**Freightliner
Service Bulletin**

General Information

Air Cleaner Support Bracket Bolt Replacement

Fig. 1, Air Cleaner Housing Rear Mounting

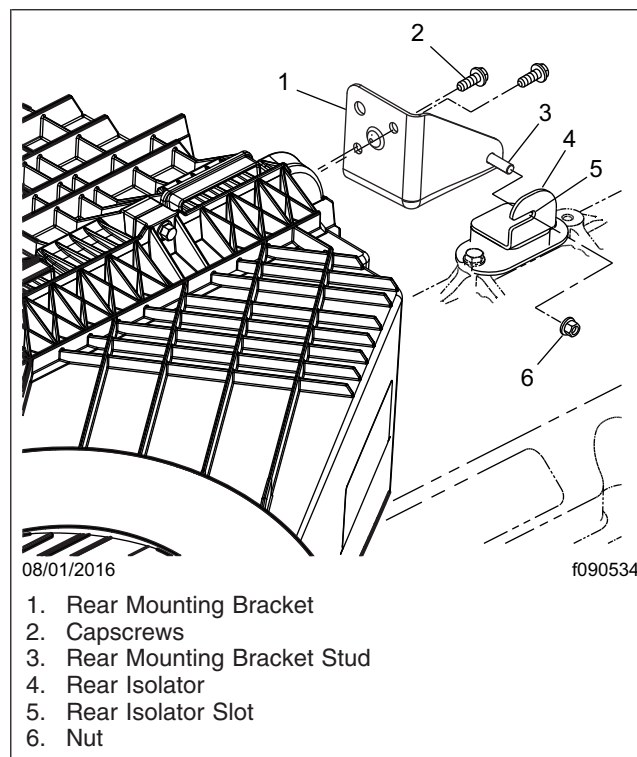
On New Cascadia vehicles, the air filter housing rear mounting bracket bolts may be found to be loose or missing. If allowed to continue, this can lead to complete bolt failure which will allow the filter housing to rest on and possibly wear through the valve cover. If the filter housing is not properly supported it can also lead to under-hood air being ingested into the engine, possibly generating Detroit air inlet temperature fault codes. To address this issue, the vehicle manufacturing plants have updated their process to add a medium strength liquid thread locker to the fasteners that hold the rear mounting bracket to the filter housing.

If this condition is observed the filter housing support bracket bolts have been running loose. They must be replaced, and the valve cover must be inspected. See the procedure below to replace the air cleaner support bracket bolts.

1. Park the vehicle on a level surface, shut down the engine, and set the parking brake. Chock the tires.
2. Open the hood.
3. Remove the rear mounting bracket stud nut. See [Fig. 1](#).

4. Remove the rear mounting bracket bolts from the housing.
5. Inspect the fasteners for thread damage. If no damage found, apply Loctite® 242 and tighten the rear mounting bracket bolts 13 lbf·ft (18 N·m).
6. Tighten the rear mounting bracekt nut 13 lbf·ft (18 N·m).
